IMPORTANT SAFETY RECALL – 16V-477

Safety Notice

SN642

SUBJECT: Hydraulic cylinder

Figure A. Hydraulic Cylinder Location

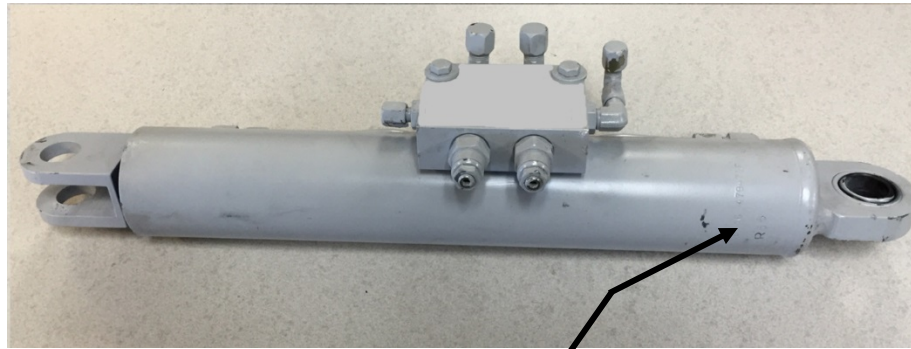
Using figure A, locate the hydraulic cylinders for the leveling and jib functions. Boom tip covers will need to be removed to inspect the jib articulation and jib extend cylinders. Using figure B, inspect the date code on the hydraulic cylinder. Note that some units will not have a hydraulic extend jib cylinder.

Dealers and Installers: A letter is being sent to owners of affected units. If an owner contacts you about this bulletin, contact TEREX Utilities, at 605-882-4000, for further instructions. The repair will take 1 hour for changing the master leveling cylinder, 4 hours for changing the boom tip leveling cylinder, 2 hours for changing the jib articulate cylinder, and 2 hours for changing the jib extend cylinder.

Figure B. Hydraulic Cylinder Date Code

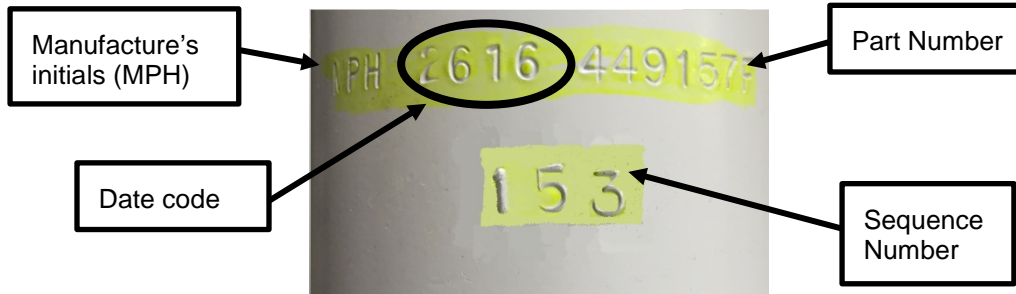
The first two numbers in the date code are the week the cylinder was manufactured. The second two numbers are the year the cylinder was manufactured. Example 2616 was manufactured week 26 in 2016 (June 27th, 2016). Sequence number 153 represents this was the 153rd cylinder manufactured in week 26 in 2016.

Any MPH hydraulic cylinder that has a date code between 1316 and 2416 (March 28th, 2016 through June 17th, 2016) with the following part number stamped in the case is subject to the recall and will need the hydraulic cylinder replaced.

Any hydraulic cylinder listed above with a date code before 1316 and after 2416 (before March 28th, 2016 and after June 17th, 2016) is not subject to the recall.

Any hydraulic cylinder listed above with an "R" stamped before the sequence number is not subject to the recall. Below is a cylinder with an "R" stamped before the sequence number.

Cylinder part numbers: 449154, 449157, 457545, 475781, 479473, 479573, 604468, and 614140
